T ECHNICAL INFORMATION

Subject ▶ Modification of Lock Plate

For Models ▶ LS1013

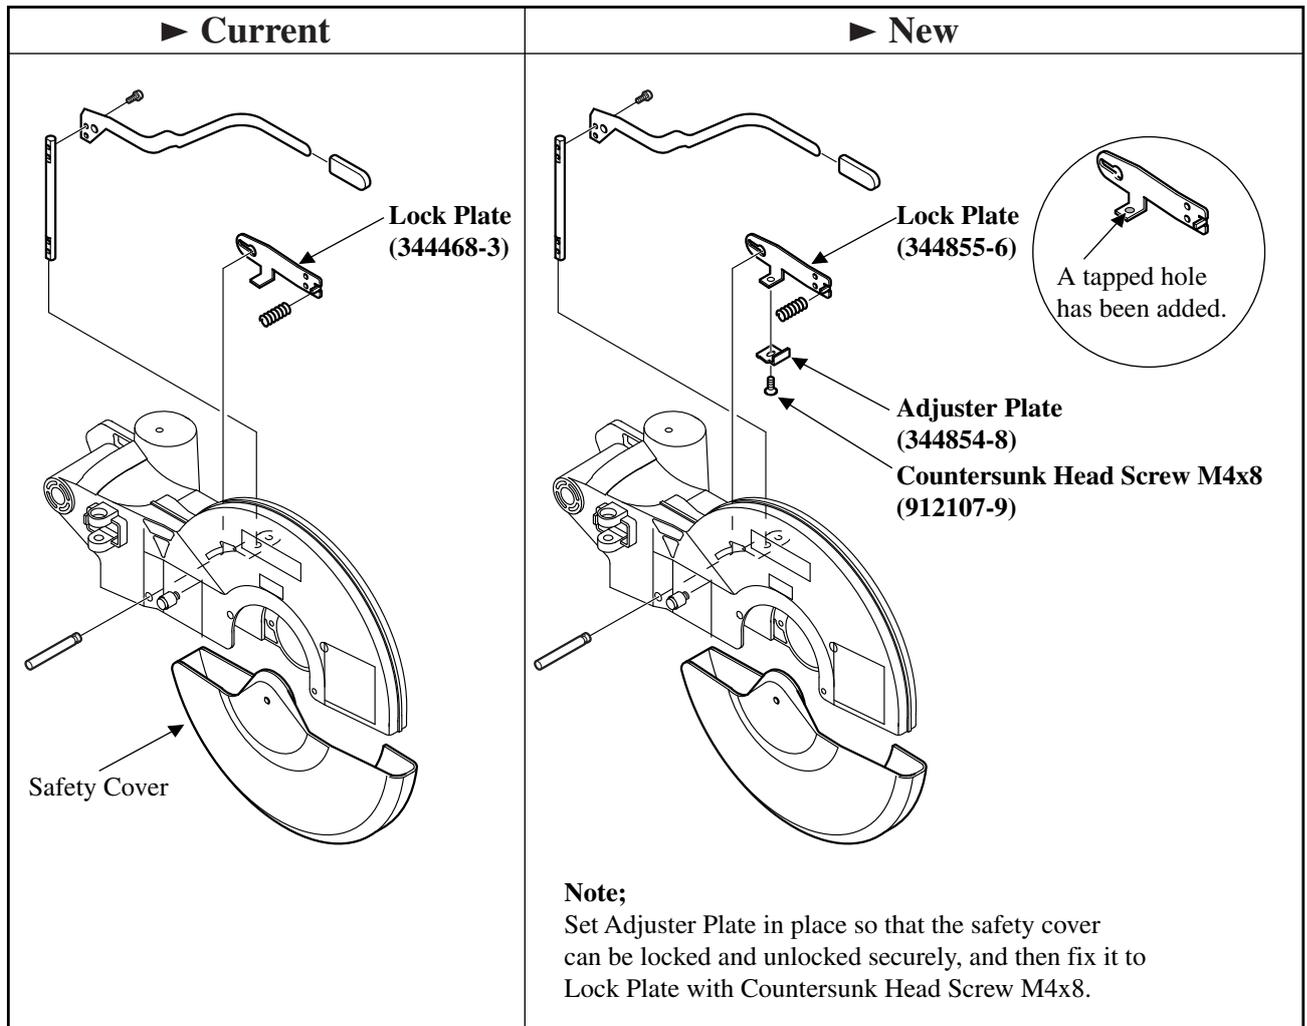
Description ▶ In order to conform to the European Standards, the Lock Plate has been modified, and one each of Adjuster Plate and Countersunk Head Screw has been added as illustrated below. With this modification, the safety cover can be locked more securely.

Item No.	Current part	Q'ty	I/C	New part	Q'ty	Note
E10	Lock Plate 344468-3	1	No	Lock Plate 344855-6	1	Interchangeable as a set
E25	-----			Adjuster Plate 344854-8	1	
E26	-----			Countersunk Head Screw M4x8 912107-9	1

From serial No.68398E (Sept.,1999)
